5.2 Air Quality Impacts

5.3 Hydrological Impacts

5.4 Visual Amenity Impacts

Figure 2 – Proposed Revegetation and Screening Works (Reproduced from the Proponent's Environmental Assessment)

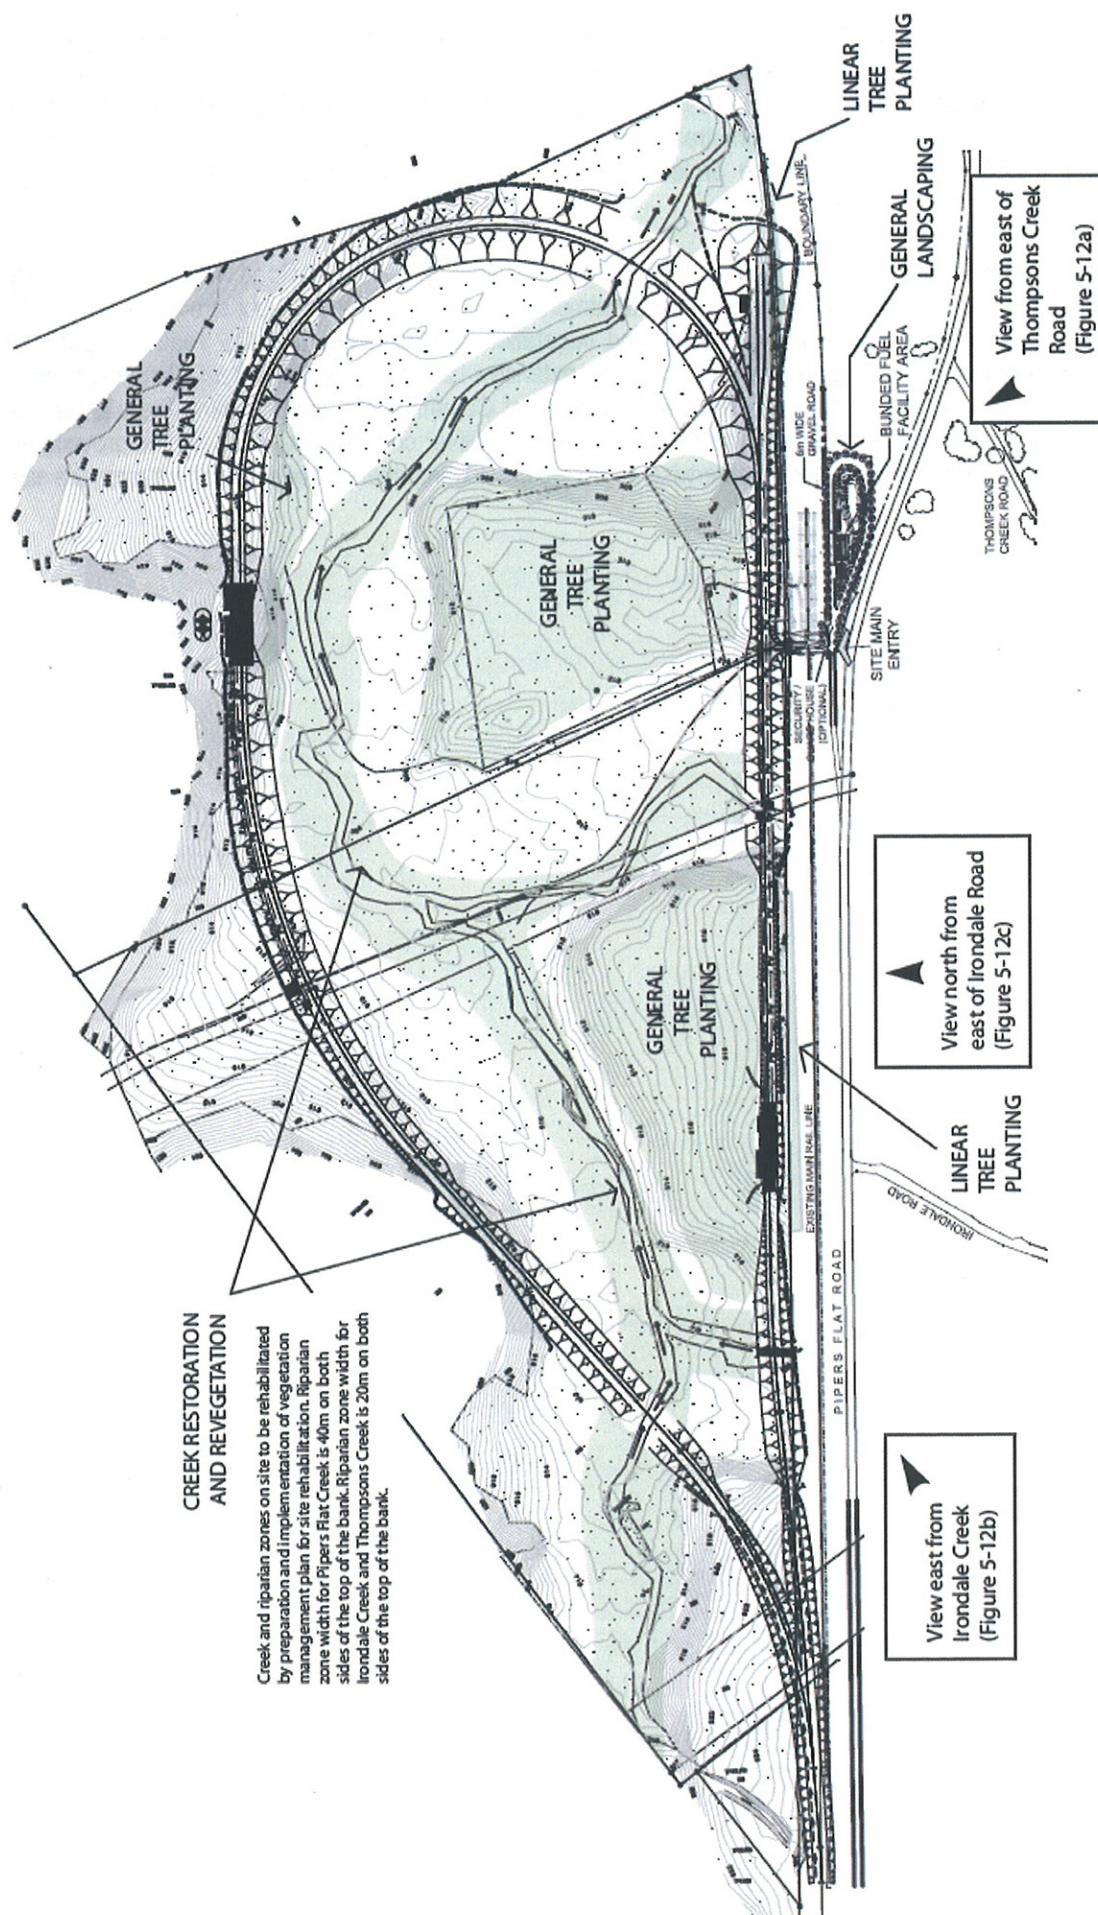
Impacts on potentially affected residential properties and users of Pipers Flat Road would be significantly reduced through the use of proposed building façade treatments which would blend project structures into the landscape, while proposed on-site revegetation works and vegetation screening would further reduce impacts (Figure 2). These works would be implemented as part of an extensive Landscape Management Plan which the Proponent has committed to implement as part of its Statement of Commitments. Implementing the plan would not only serve to mitigate visual amenity impacts, but would also deliver considerable ecological improvements through the rehabilitation of the site and its otherwise degraded creeks and riparian zones which traverse the site.

The mitigation measures proposed are supported by the Department and, if implemented, the Department believes would reduce visual amenity impacts to acceptable levels. The Department has therefore reflected these measures in the recommended conditions of approval to ensure that they are undertaken. Further, the Department has strengthened the Landscape Management Plan proposed by the Proponent by requiring that it be further developed in consultation with the Council, the Department of Environment and Climate Change, Department of Primary Industries, Sydney Catchment Authority and the Department of Water and Energy to ensure that the plan delivers the predicted visual amenity and ecological benefits.
